Technical Service Bulletin

MODEL(S) AFFECTED: **T7 Rider Scrubber** - Models manufactured before serial number 10613731 (April 9, 2013).
Models manufactured in Europe before serial number T7xxx06952 (April, 2013).

SUBJECT: Potential drain hose damage due to careless machine operation when transporting with squeegee raised. If the right side of the squeegee assembly strikes a wall or obstruction with excessive force (see photos below), the left edge of the squeegee lift bracket will crush the drain hose causing damage and water leakage.

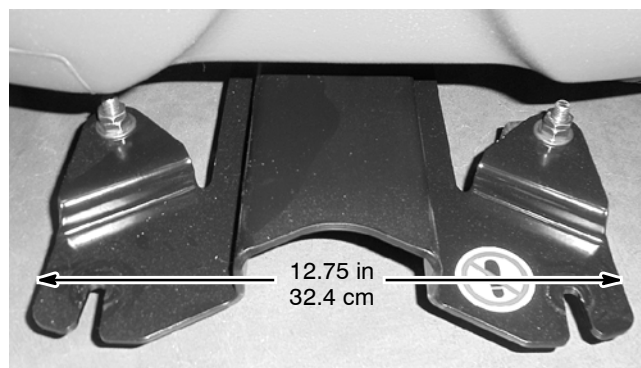
When squeegee assembly strikes a wall with excessive force, the left side of the squeegee lift bracket will crush drain hose.

Solution Option 1: (preferred)

Install upgraded bracket (p/n 1018725). The width of the upgraded bracket measures 12.75" (32.4 cm).

Solution Option 2:

Remove existing protective edging and install longer piece as shown (p/n 1020168).
